**Report on**  
**Groundwater and Surface Water Contamination**  
**at the Flambeau Mine**

June 5, 2009

**Figure A: Plan View Groundwater Flow**

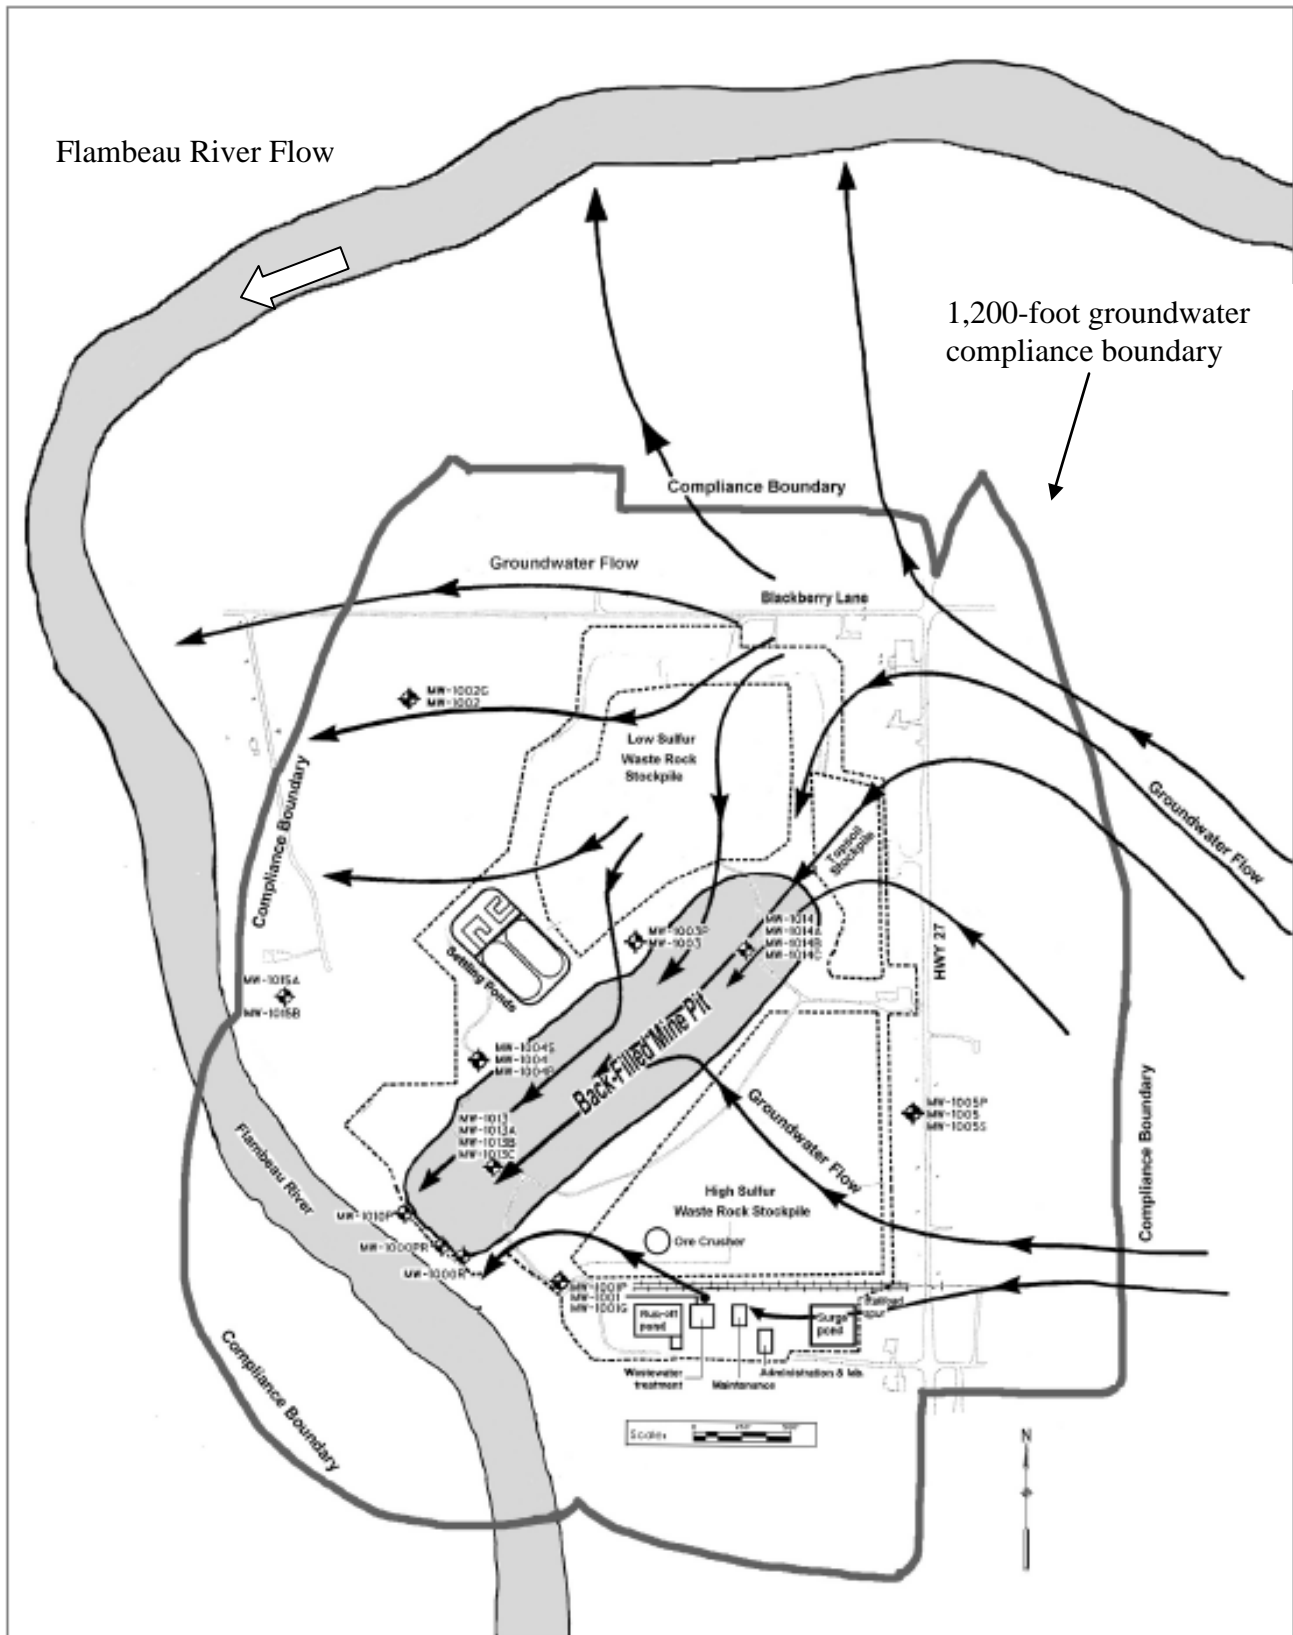
During mining, water was pumped from the pit to keep it relatively dry. This pumping caused a groundwater cone of depression to form around the pit, directing all groundwater flow during mining toward the pit. At mine closure the pumping ceased and natural groundwater flow patterns were restored. The southwestern edge of the pit is 140 feet from the Flambeau River. The pit is separated from the Flambeau River by a slurry cutoff wall designed to limit groundwater flow to/from the river both during and after mining. The post-mining groundwater hydrology is described as flow from the pit towards the Flambeau River (see Figure A and Figure B).

Wisconsin law requires the establishment of two different boundaries at mine sites for enforcement of groundwater quality standards. The first, known as the compliance boundary, is located 1,200 feet from the outer perimeter of the mining waste facility (NR 182.075). The term "compliance boundary" was changed to "design management zone" when the statute was amended in 1998; it is referred to in the present document as the "compliance boundary". In the case of the Flambeau Mine, the unlined backfilled pit constitutes the mining waste facility. See Figure A for the location of the Flambeau Mine compliance boundary.

It is possible that pit water could be moving around the ends of the slurry wall. Inspection of the projected groundwater flow directions in Figure A and the groundwater potentiometric surface lines in Figure B both support this hypothesis. It appears that both MW-1000PR<sup>42</sup> and MW-1010P are screened in bedrock. Since it is apparent from the MW-1000PR data that groundwater contamination is exiting the

***Recommendation: Place nested wells at either end of the slurry wall; if MW-1000R (25' deep) is active, this could serve as one of the new monitoring wells; a deeper well should be constructed next to it. In addition, samples should be taken from MW-1001 which, although not located at the slurry wall, is nested (33', 52', 95') and located just to the southeast of the wall and would aid in determining groundwater flow direction. A monitoring well on the southern compliance boundary would ensure no contaminants are moving in that direction.***

**Figure E: Stream C Water Quality Data**

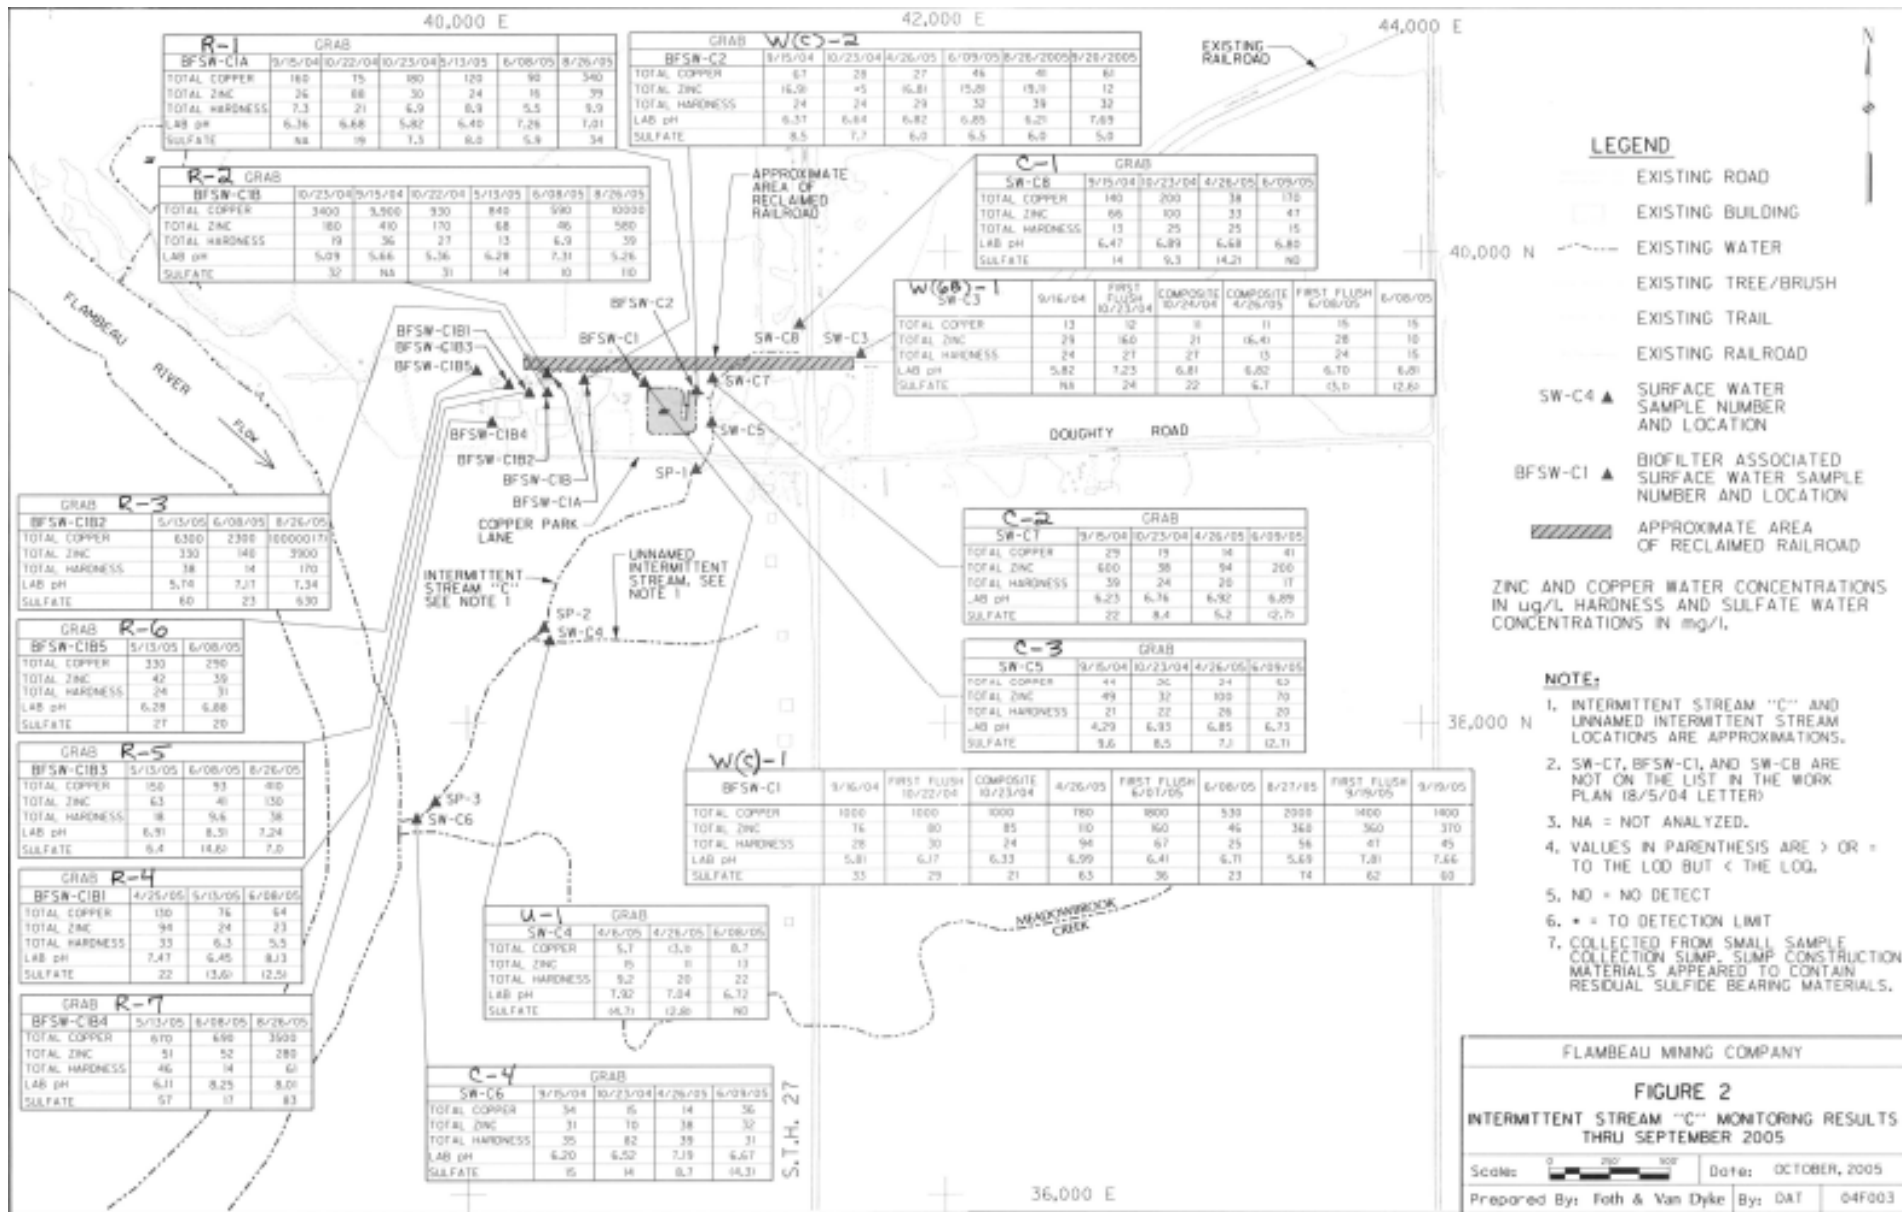
In reviewing the Foth & Van Dyke data for Stream C it is also evident that the portion of Stream C above the junction with the wetland/biofilter also carries significant copper, and possibly some zinc contamination (See Figure E, station SW-C8). In general the data also indicates the pH is normal, with some fluctuations, and the sulfate level is low. These would all suggest that metals are being sequestered in the wetland/biofilter, but that copper may be attached to suspended sediment or organic particles flowing from the wetland/biofilter. It could also be that there is just too much copper to be effectively filtered by the existing wetland. There is little data available on total suspended solids to correlate with the available water quality data.

In either case an expanded wetland/biofilter could be constructed to give more residence/treatment time to remove copper not only from the mine site drainage, but also to include water from the upper portion of Stream C above the Lot, which also shows indications of contamination.

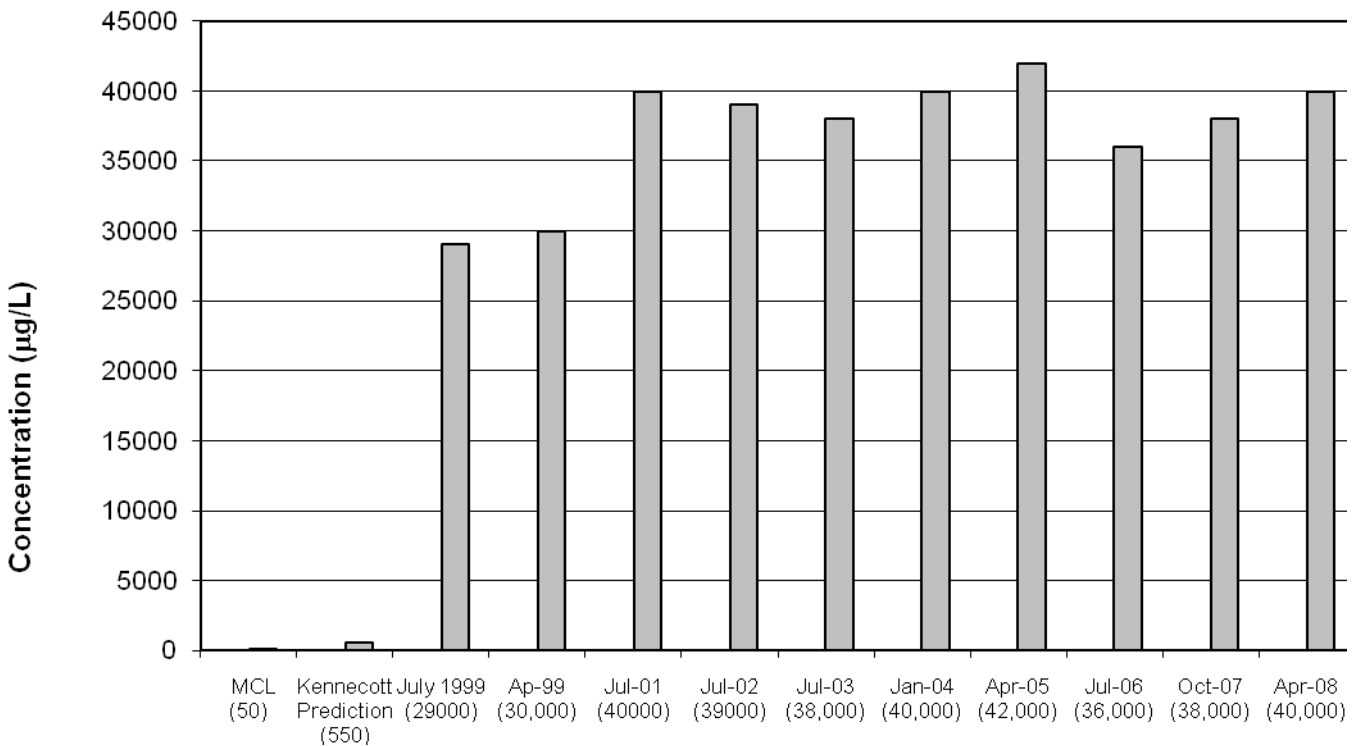
Column testing by the Flambeau Mining Company in 1997 was not able to produce the manganese concentrations predicted, but it was thought that “with an extended time manganese levels would decrease to those predicted in Table 4-23”<sup>19</sup>; i.e. 2 mg/L (2,000 µg/L) at 1% carbon dioxide.<sup>20</sup> However, ten years after backfilling, manganese concentrations in pit pore water remain underestimated by more than an order of magnitude in four of the eight pit monitoring wells (MW-1013, 1013B, 1013C, and 1014B), and fluctuate strongly in three of the remaining four (MW-1013A, 1014, 1014A) (Table 4 and Figure G).
